NESPOR 1ST ADDITION TO SEDGWICK COUNTY, KANSAS LOT 1 BLOCK 1

RE: S/D 99-17 -- One-Step Final Plat of NESPOR FIRST ADDITION

RE: S/D 99-17 -- One-Step Final Plat of NESPOR FIRST ADDITION

CASE NUMBER: S/D 99-17 - NESPER 1ST ADDITION

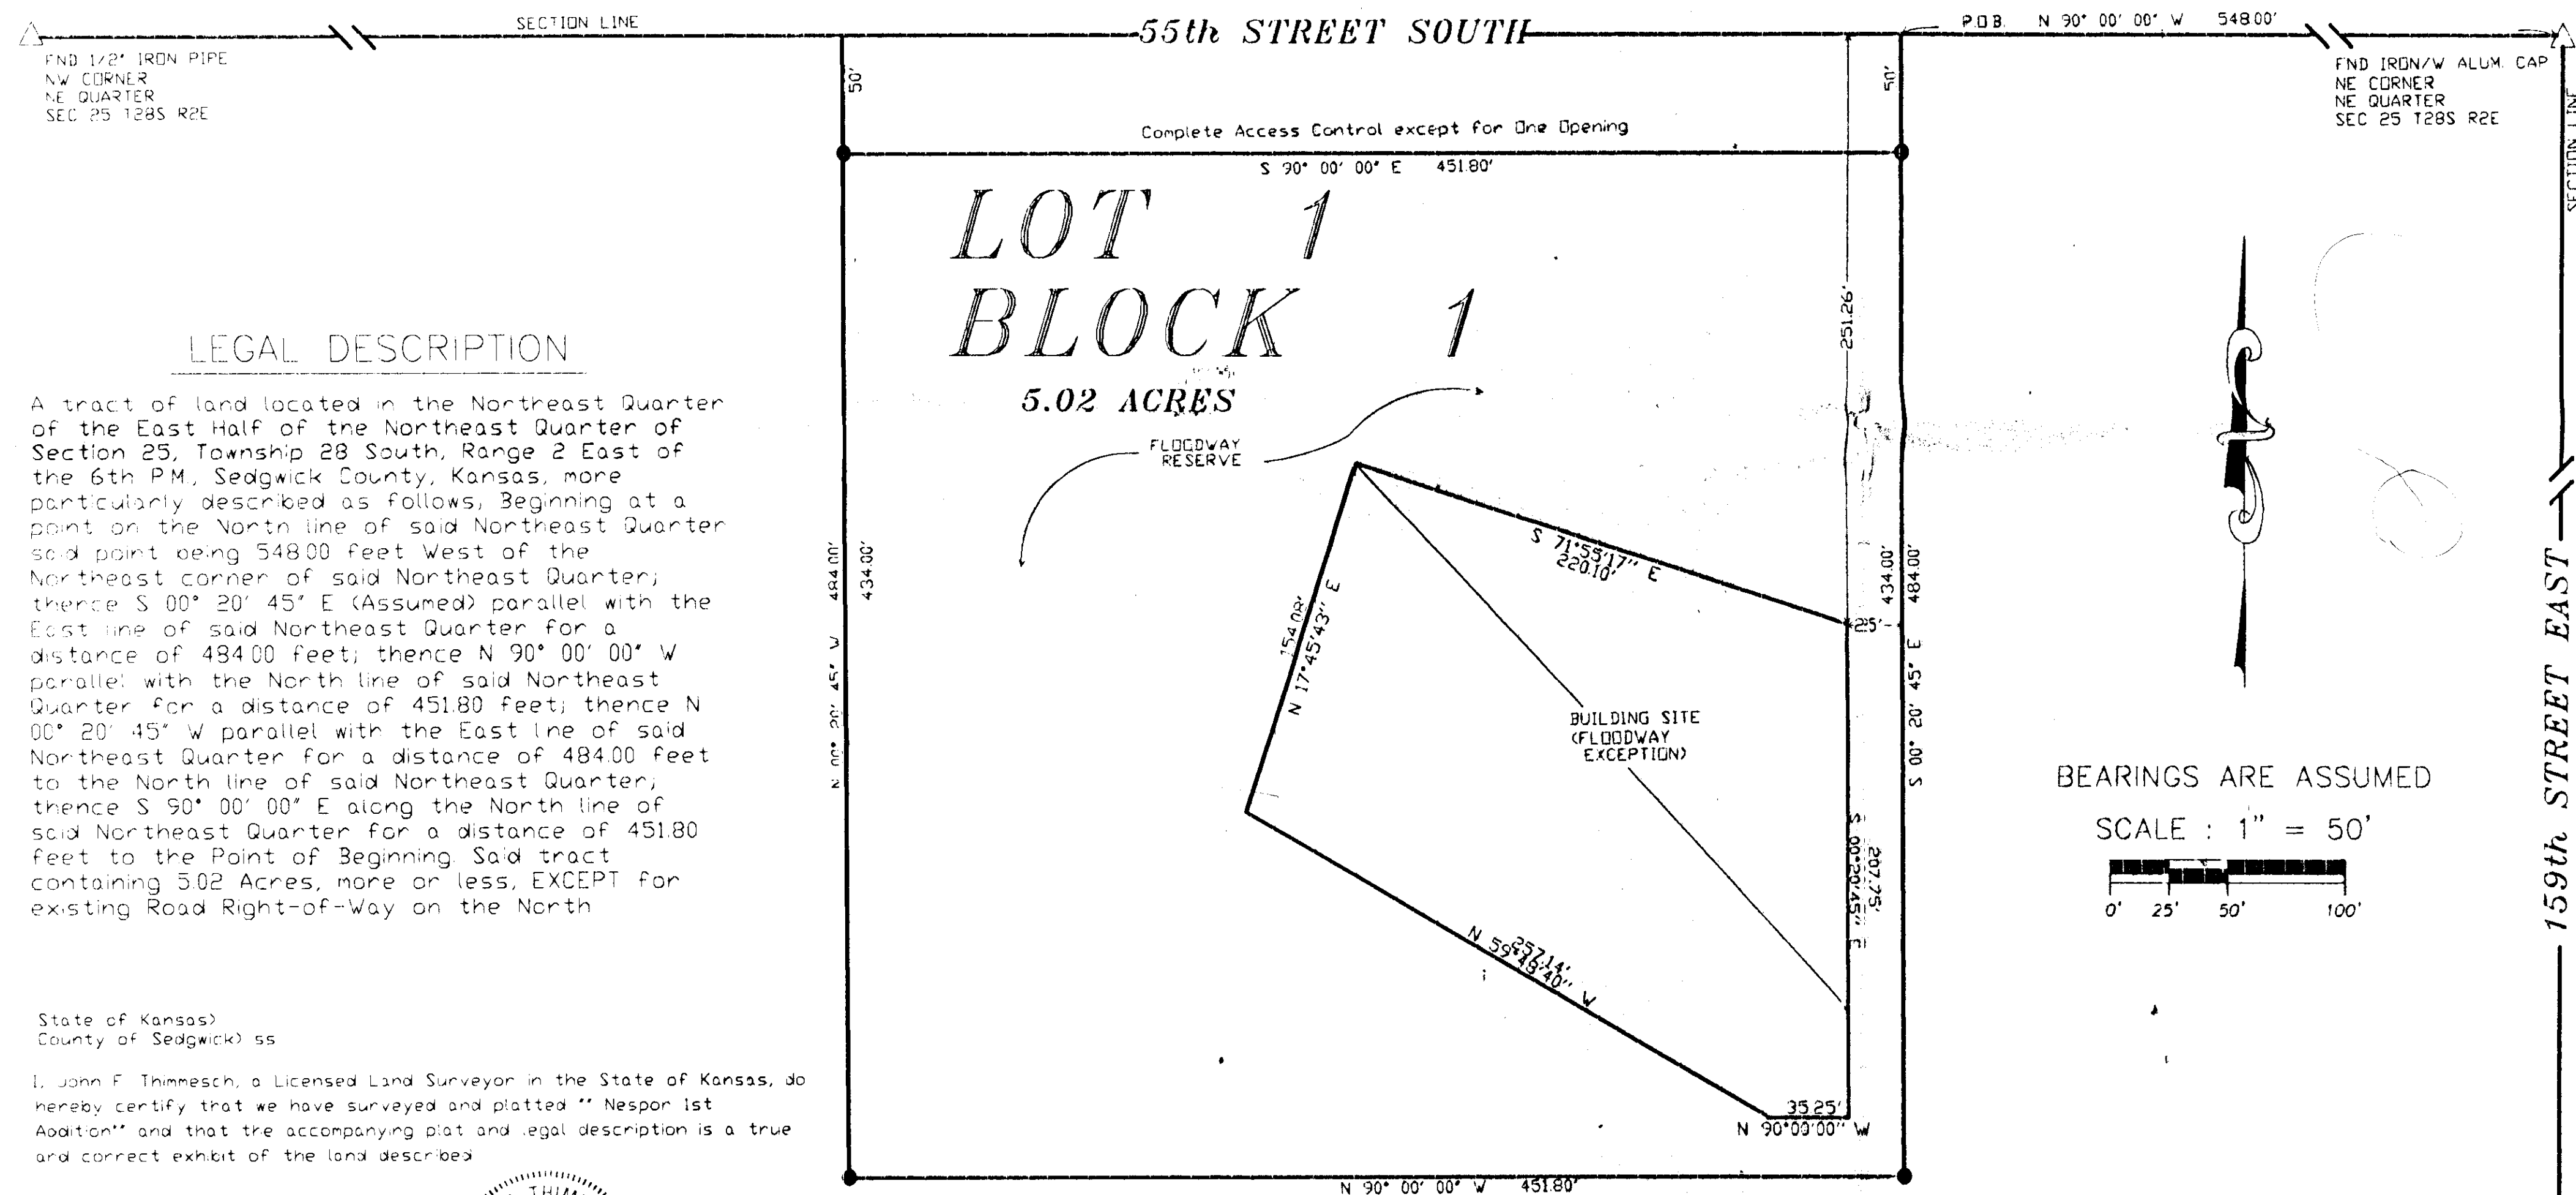
- A. Since neither municipal water nor sanitary sewer is available to serve this property, the applicant shall contact the Environmental Health Division of the Health Department to find out what tests may be necessary and what standards are to be met for approval of on-site sewerage facilities and water wells. A memorandum shall be obtained specifying approval.

County Health needs to comment on the buildable area of the site as the floodplain and pond may present constraints for construction of an on-lot sewage system. County Health has approved the location of the sewage lagoon contingent upon the applicant receiving a letter of map revision from FEMA. In the alternative, the location of the lagoon will need to be within the western portion of the "proposed building location" as denoted on the preliminary plat. The applicant shall place a note on the face of the plat clarifying lagoon placement.

- B. If improvements are guaranteed by petition, a notarized certificate listing the petitions shall be submitted to the Planning department for recording.
- C. County Engineering needs to comment on the status of the applicant's drainage plan. The drainage plan is approved. A floodway reserve needs to be platted along with minimum building pad elevations. The creation of the floodway reserves and the standard floodway language needs to be included in the plat's text.
- D. The final plat tracing shall denote complete access control except for one opening along 55th St. South. Access controls shall be referenced in the plat's text.
- E. The first line of the legal description needs to be revised to reference the northeast "quarter".

- F. The County Commissioners signature block needs to be revised.
- G. The applicant is reminded that a platting binder is required with the final plat. Approval of this plat will be subject to submittal of this binder and any relevant conditions found by such a review.

- H. The Planning Commissioner signature block needs to be revised to include, "Dated this ____ day of _____, 1999."
- I. The notary signature block needs to be revised to eliminated reference to "Waco Township"

- J. The signature blocks need to be revised to reference "1999".
- K. The applicant shall install or guarantee the installation of all utilities and facilities which are applicable and described in Article 8 of the MAPC Subdivision Regulations. (Water service and fire hydrants required by Article 8 for fire protection shall be as per the direction and approval of the Chief of the Fire Department.)

- D. The final plat tracing shall denote complete access control except for one opening along 55th St. South. Access controls shall be referenced in the plat's text.
